Village of Arlington Heights
Plan Commission
Board Room, 3rd Floor
Arlington Heights Village Hall
33 S. Arlington Heights Road
Arlington Heights, IL 60005
March 27, 2019
7:30 PM

- A. Arlington 425 - Highland/Campbell/Chestnut - PC#19-001
Planned Unit Development, Preliminary Plat of Subdivision,
Rezoning from R-3 to B-5, Land Use Variation to allow a Multi-
Family use within B-5 District, Variations

REPORT OF THE PROCEEDINGS OF A PUBLIC HEARING
 BEFORE THE VILLAGE OF ARLINGTON HEIGHTS
 PLAN COMMISSION

RE: 1400 WEST THOMAS STREET SUBDIVISION - PC# 18-025
 PRELIMINARY PLAT OF SUBDIVISION, REZONING, COMPREHENSIVE PLAN
 AMENDMENT

Figure 4 illustrates the existing peak hour vehicle traffic volumes.

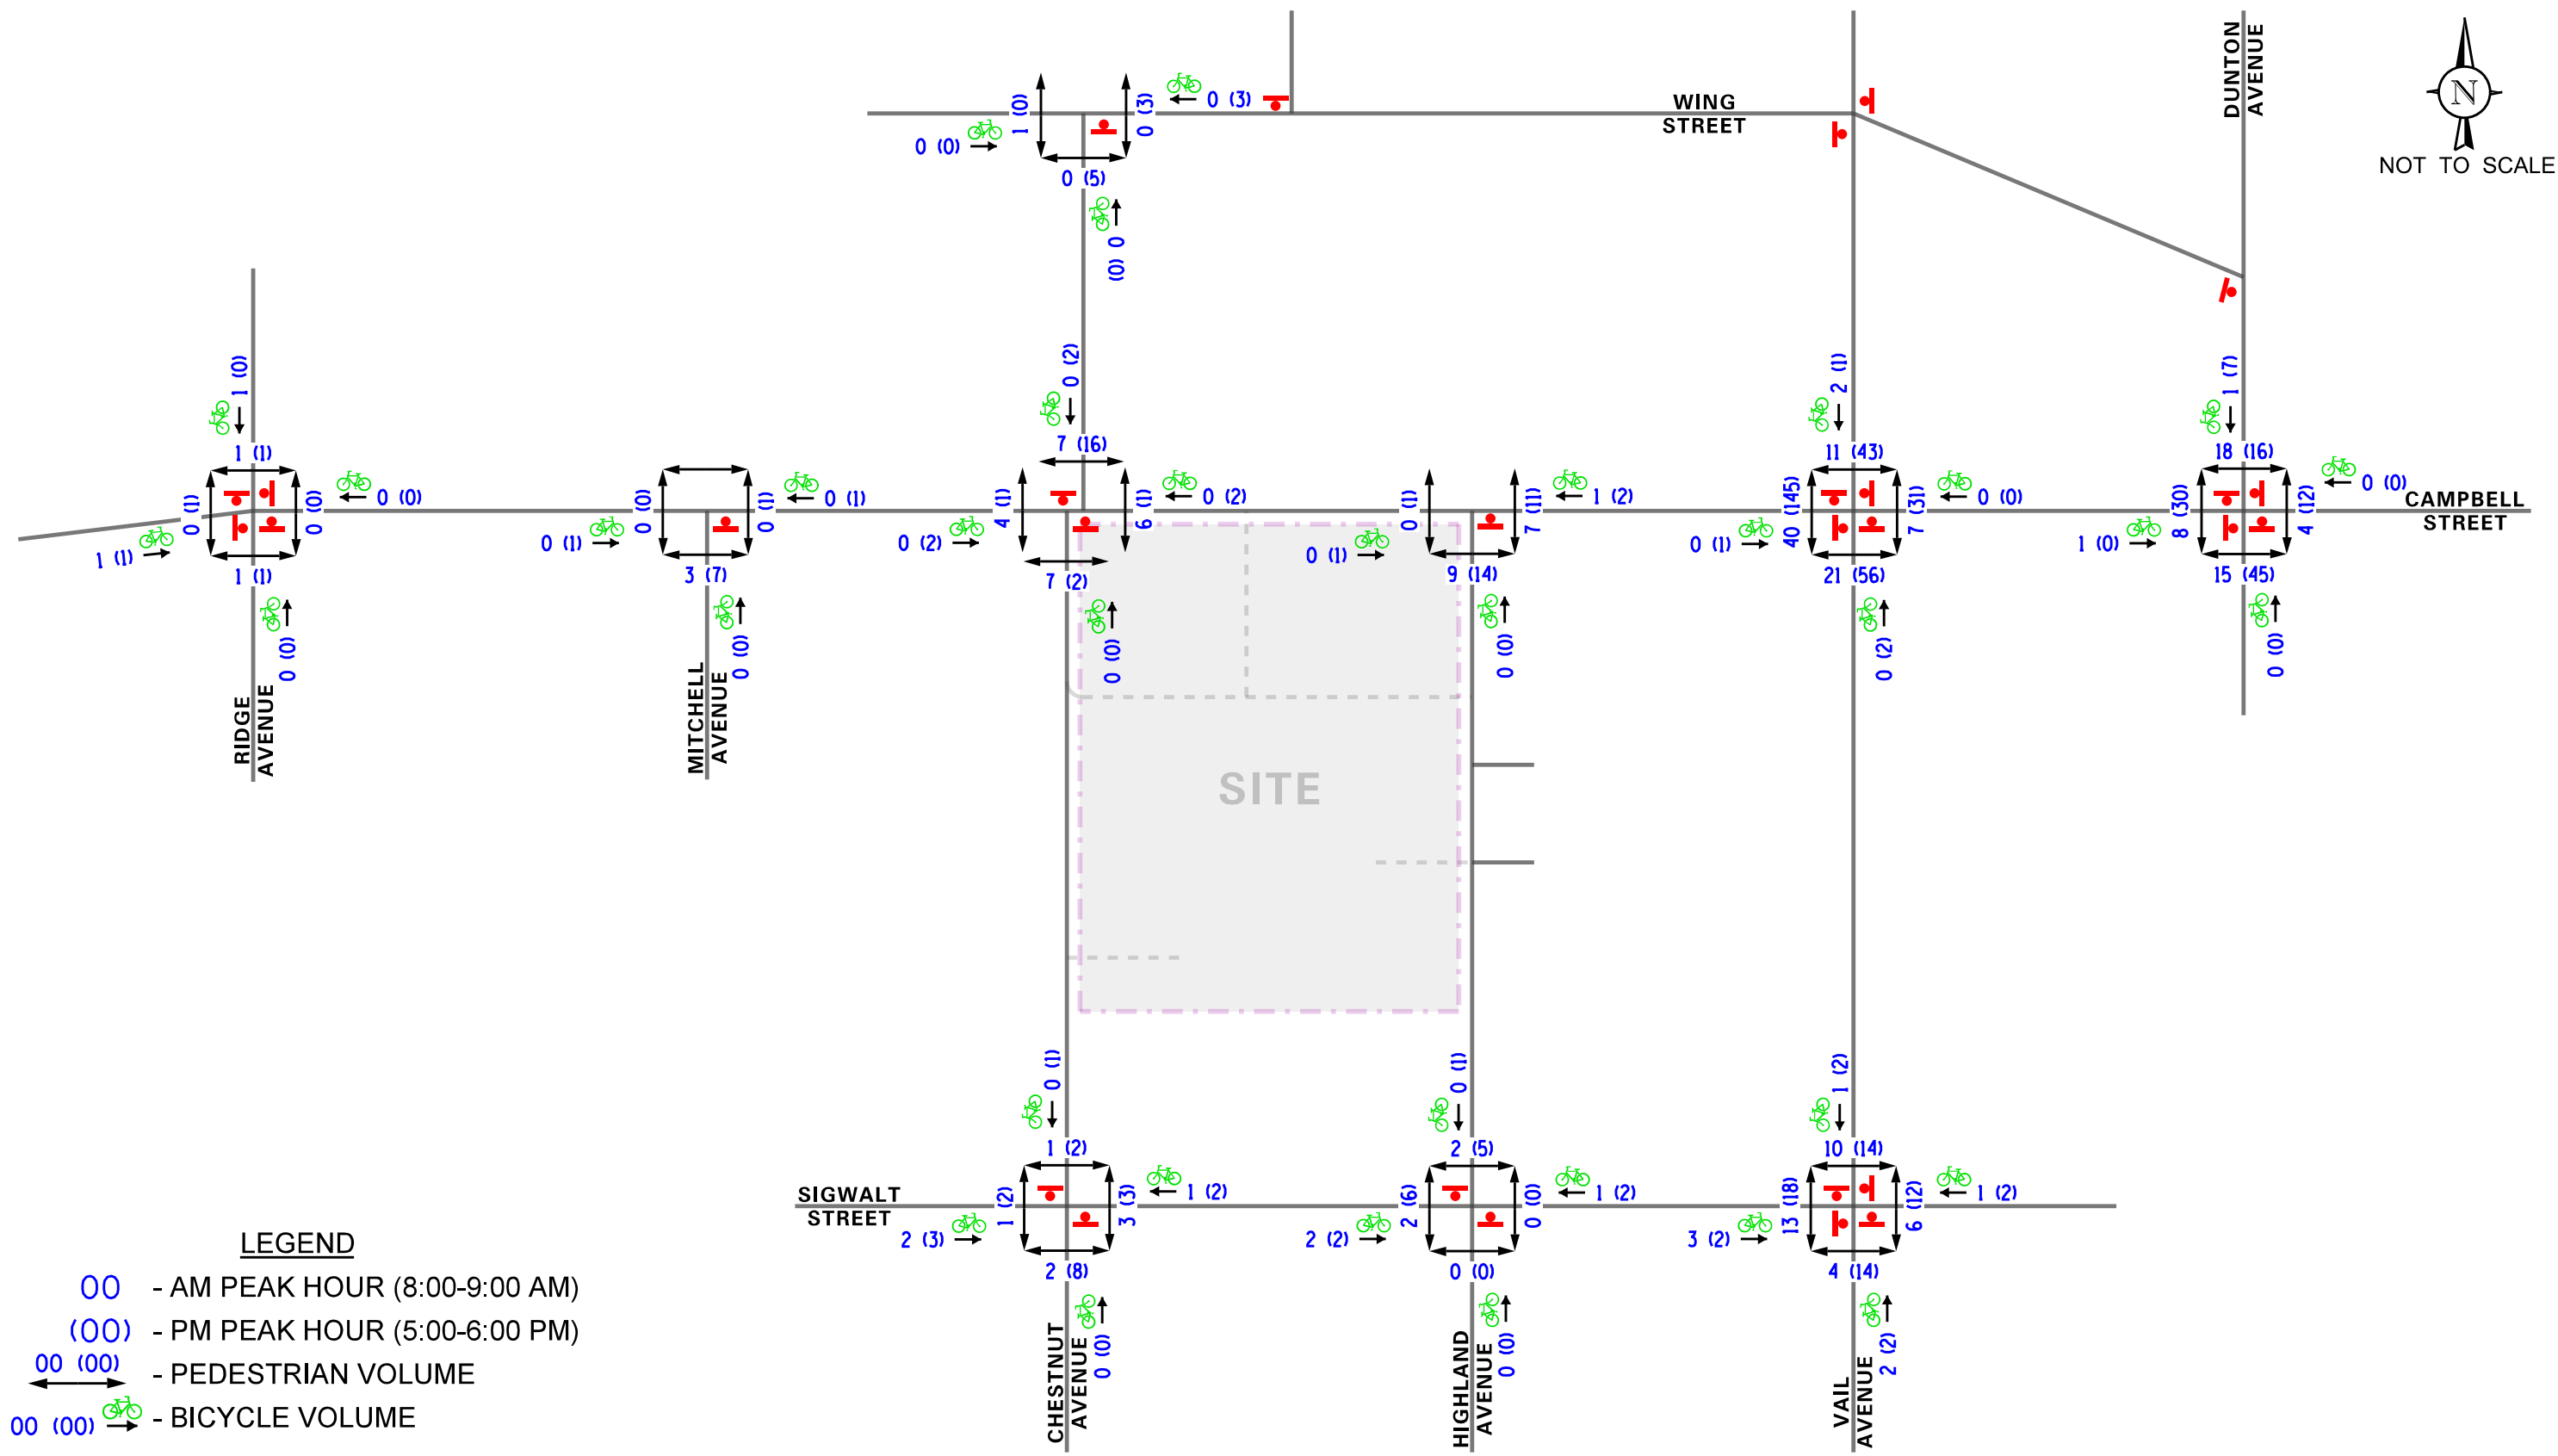
58. Traffic Report Figure 3, is incorrect for the all way stop signage shown at Wing St. and Vail Ave.
59. Traffic Report Figure 4 must be corrected for 'Inset B', which shows three intersecting driveways along the north side of the street. However, the text on page 8 refers to four driveways.

59. Traffic Report Figure 4 must be corrected for 'Inset B', which shows three intersecting driveways along the north side of the street. However, the text on page 8 refers to four driveways.

Figure 9 shows the total projected vehicle traffic volumes.

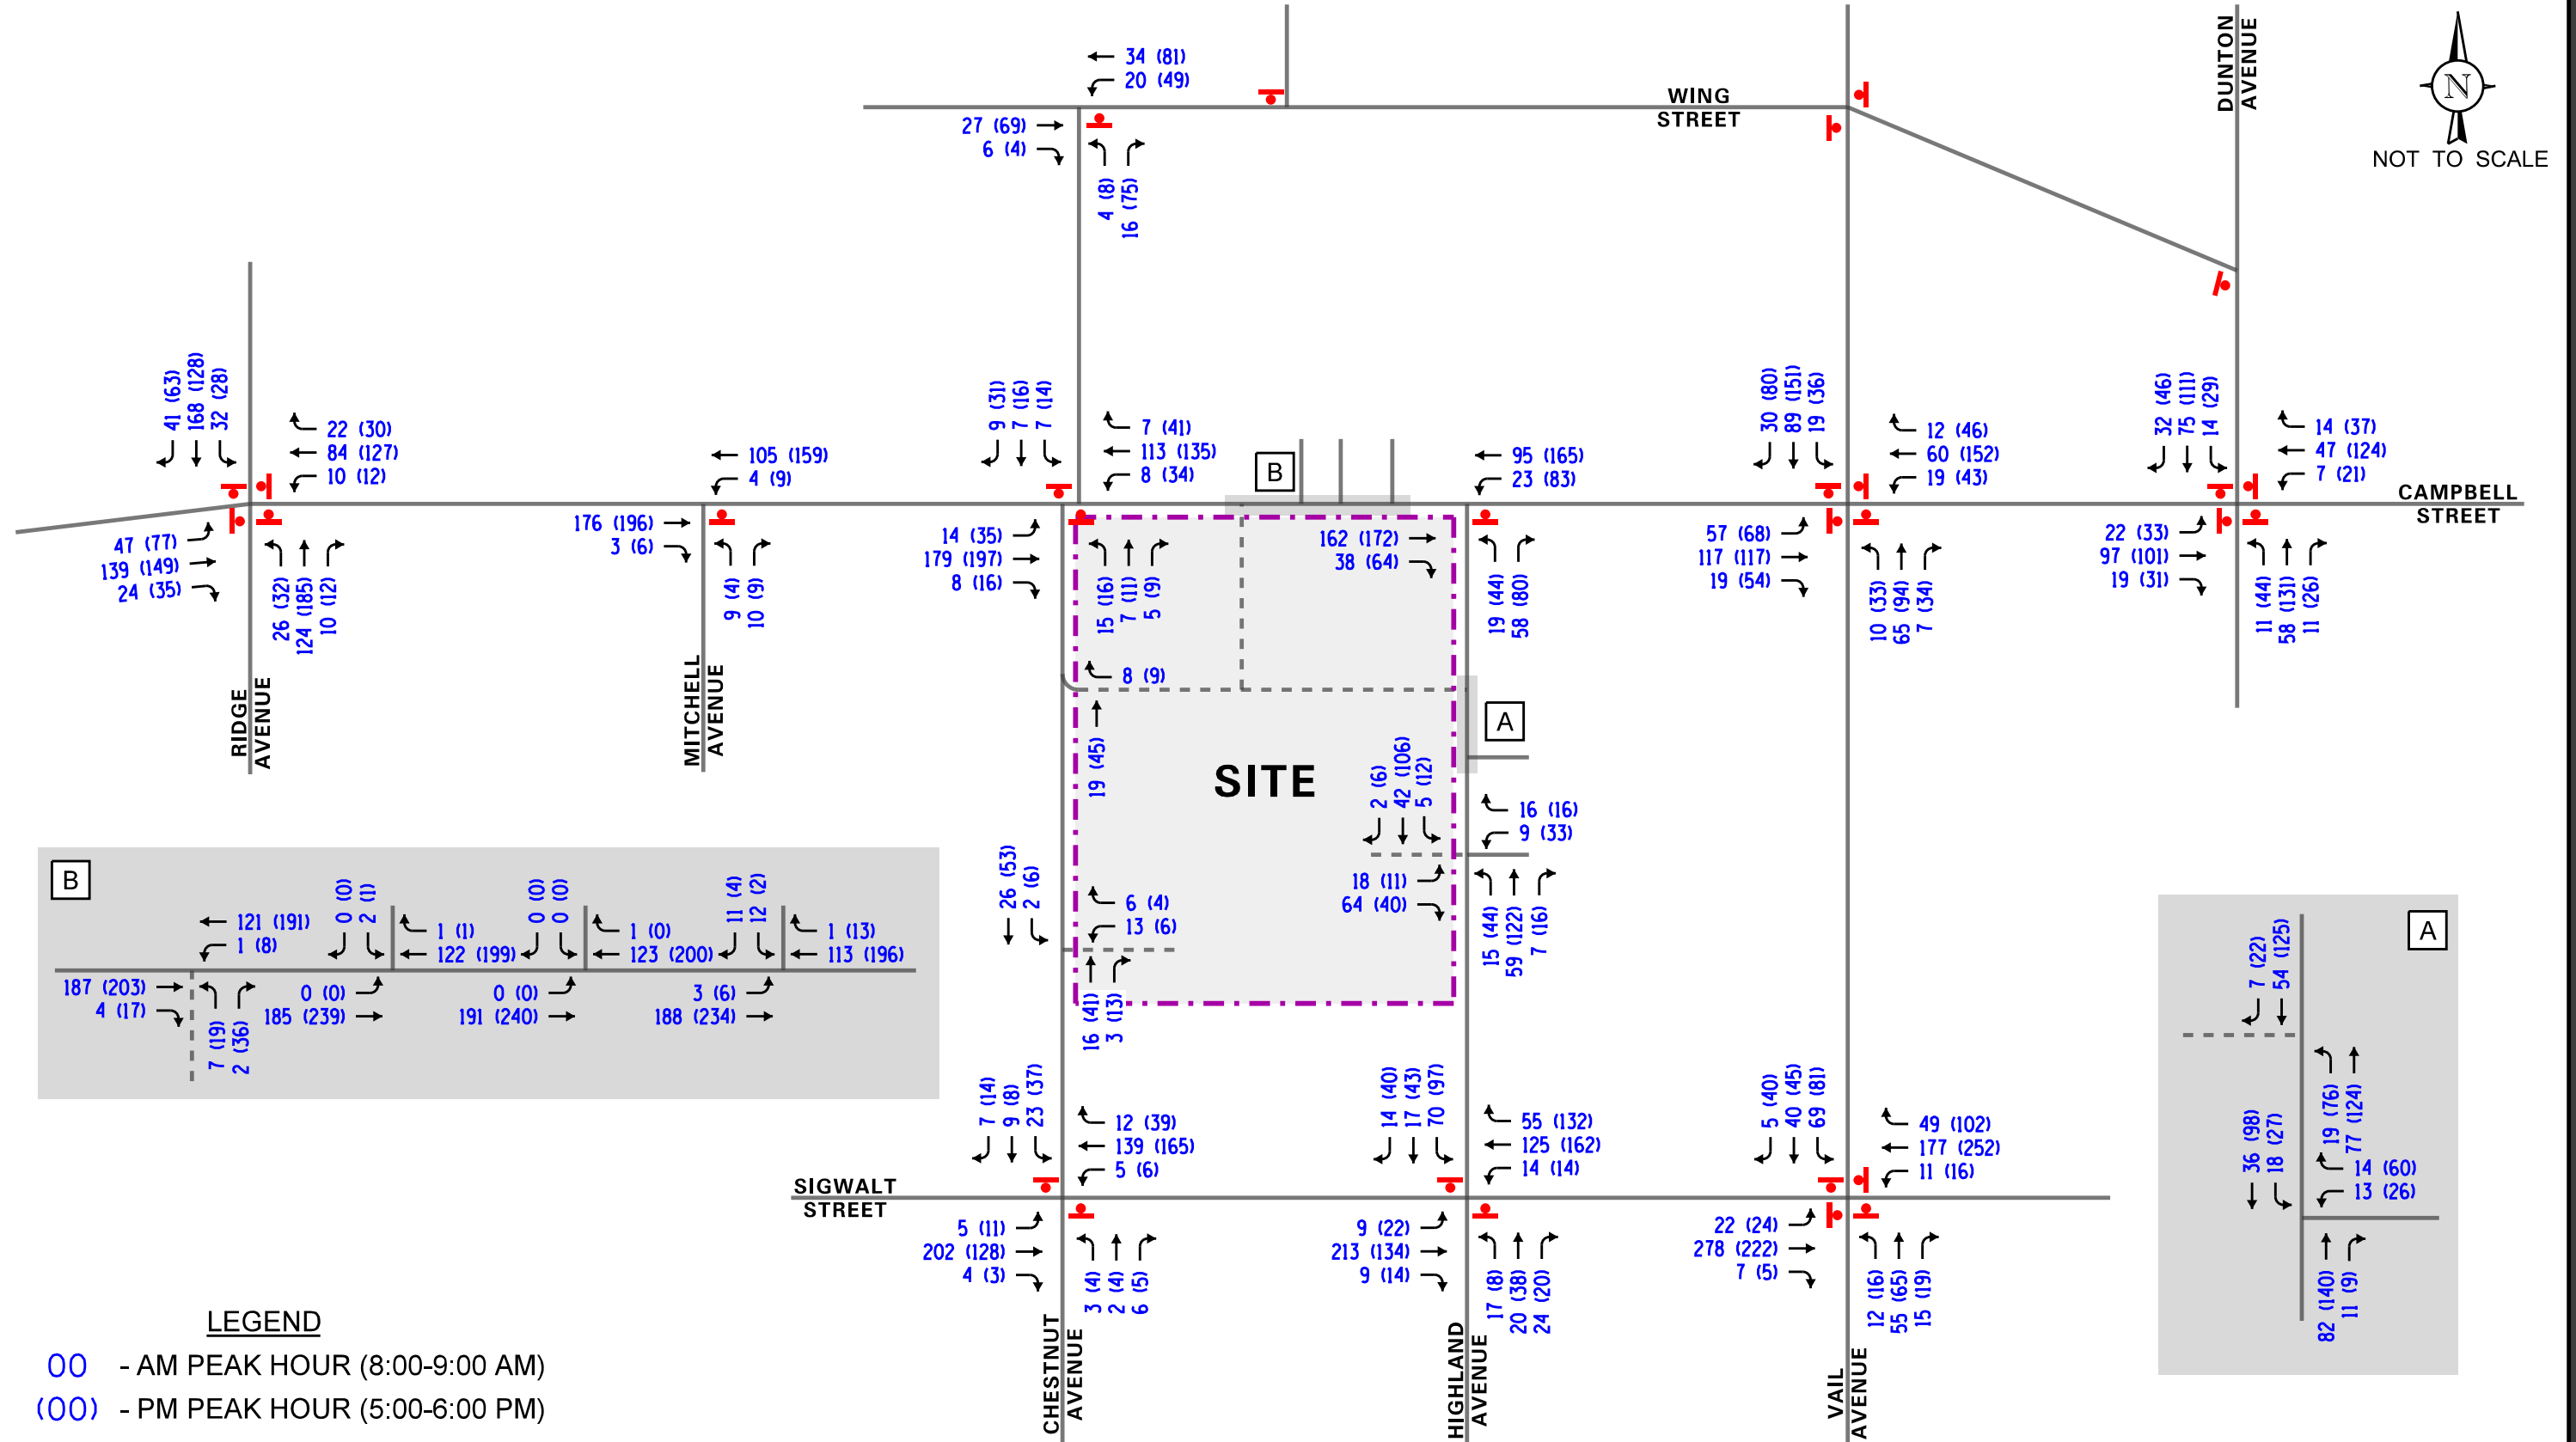
59. The traffic volumes from Figure 7 of the KLOA study, when added to the volumes in Figure 8, do not equate to the volumes shown in Figure 9. Please revise these figures to model the correct traffic volumes.
60. The parking study should be revised to include a parking analysis showing the residential uses parked at 1.5 spaces per unit, but the commercial/office/retail spaces parked per the 2018 Rich & Associates parking study of downtown parking demand (see below):

57. The traffic volumes from Figure 7 of the KLOA study, when added to the volumes in Figure 8, do not equate to the volumes shown in Figure 9. Please revise these figures to model the correct traffic volumes.
